**CERTIFICATE OF APPROPRIATENESS**

**Property:** 1917 Crockett St, Lot 1, Block 314, Shearn Addition Subdivision. The property is a vacant 2,315 square foot (47' x 49'-3") corner lot.

**Proposal:** New Construction – Residence

**Recommendation:** Deferral

**NORTH ELEVATION – FACING CROCKETT STREET**  
**PROPOSED**

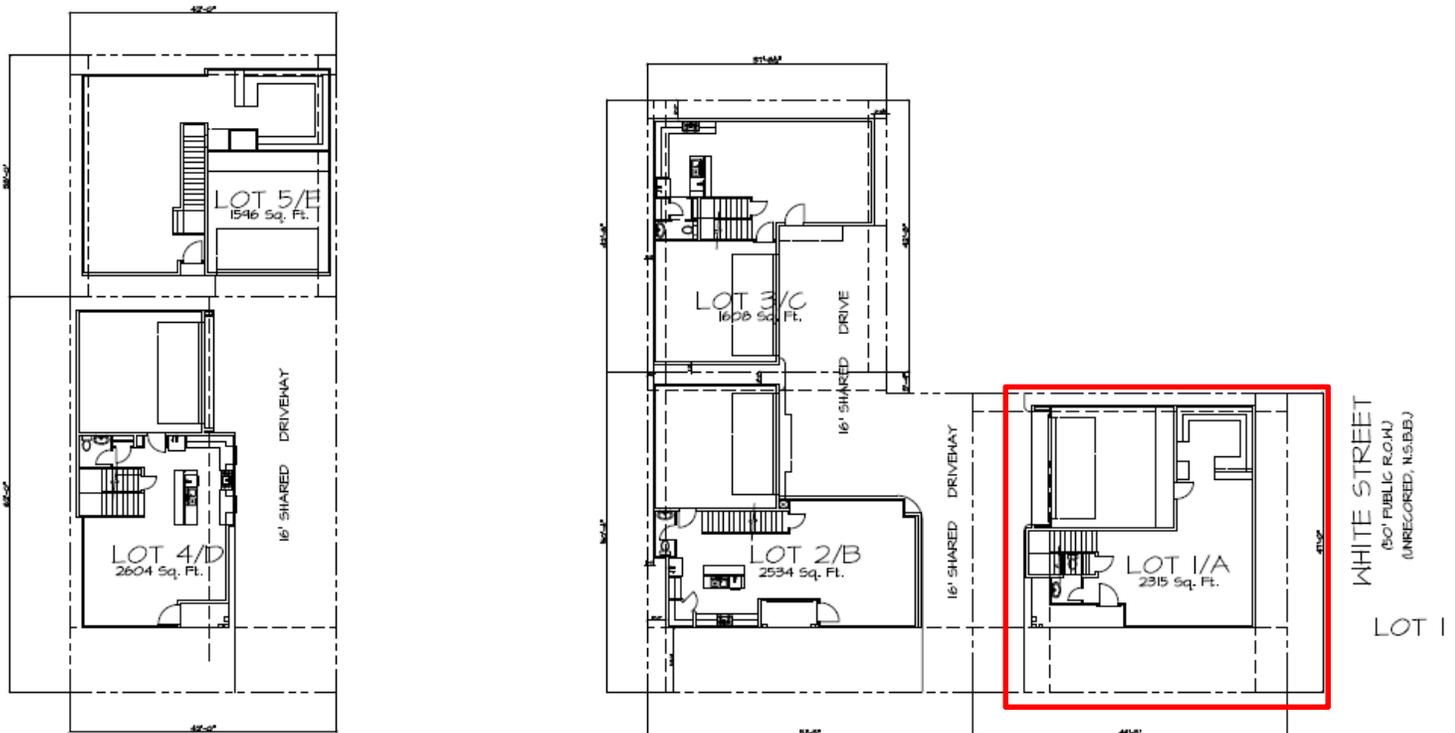
*8" cementitious siding is not an appropriate feature within the context area. Smooth-finish 4" reveal cementitious siding would be a more appropriate siding option.*

**SOUTH ELEVATION**  
**PROPOSED**

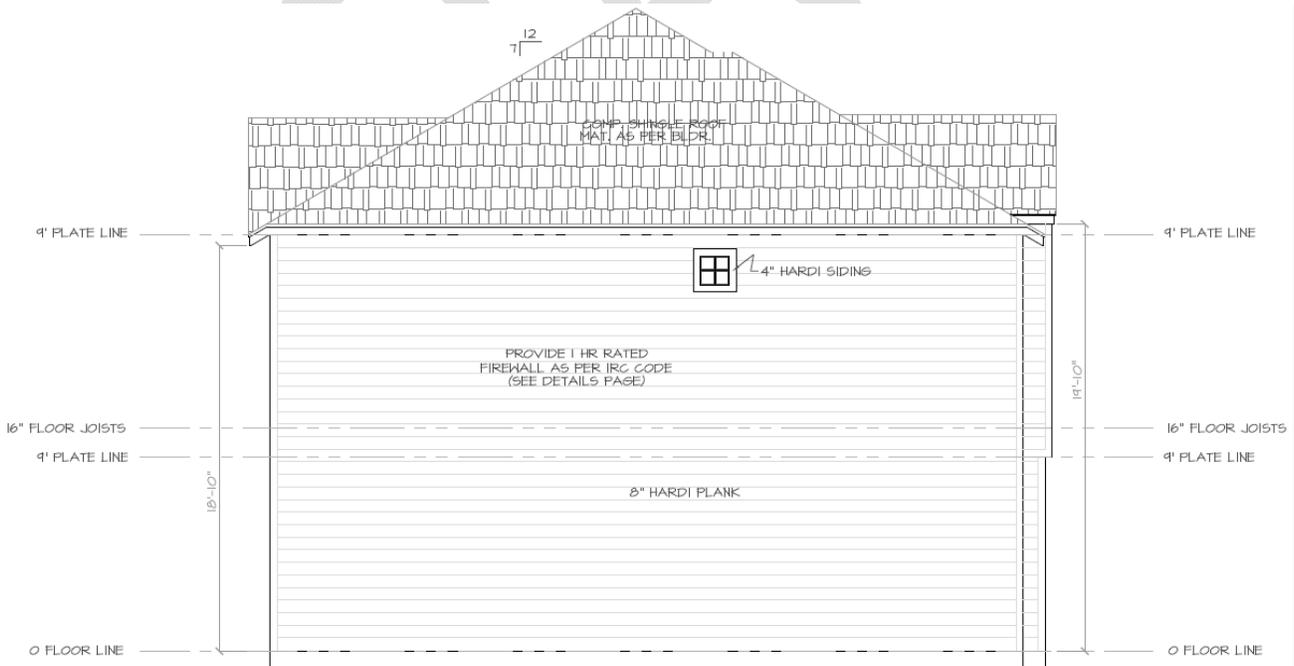
*The south elevation is lacking window openings in keeping with typical contributing structures in the area. This two-story blank wall only 2' from the south property line does not meet Design Guidelines provisions requiring traditional solid-to-void proportions for walls to windows.*
- (3) The scale and proportions of the new construction, including the relationship of the width and roofline, overall height, eave height, foundation height, porch height, roof shape, and roof pitch, and other dimensions to each other, must be compatible with the typical scale and proportions of existing contributing structures in the context area unless special circumstances, such as an atypical use, location, or lot size, warrant an atypical scale and proportions;

*The draft Design Guidelines also require traditional solid-to-void proportions for walls to windows. The south elevation lacks window openings, which is not in keeping with typical contributing structures in the area and therefore does not meet this provision.*

**PROPOSED**

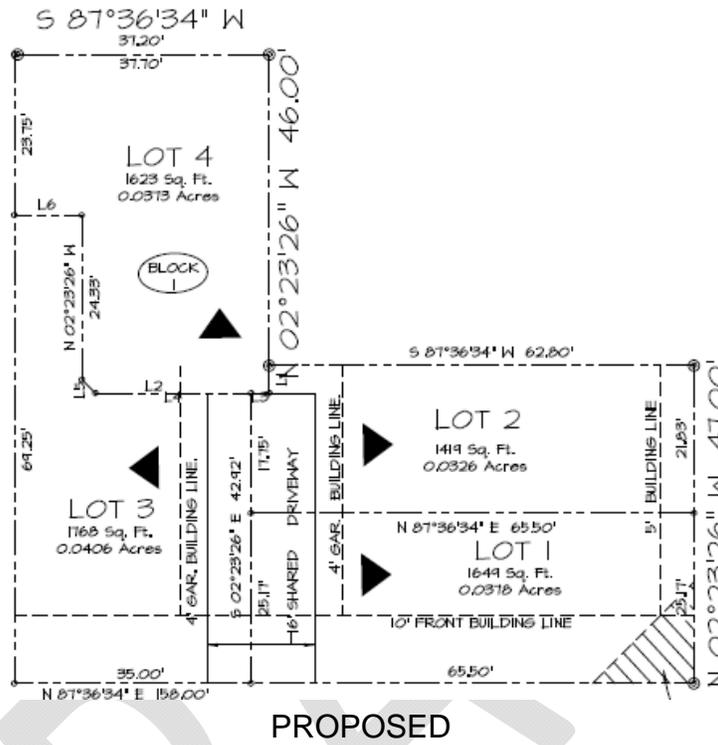
*There is one contributing structure on this blockface that has a setback of 11'. The contributing structure on White Street has an approximate setback of 5'. The current proposal has a setback of 10' on Crockett and 5' on White Street. The setback on the south side is only 2' however, which is not a typical or appropriate setback.*
- (2) The exterior features of the new construction must be compatible with the exterior features of existing contributing structures in the context area;
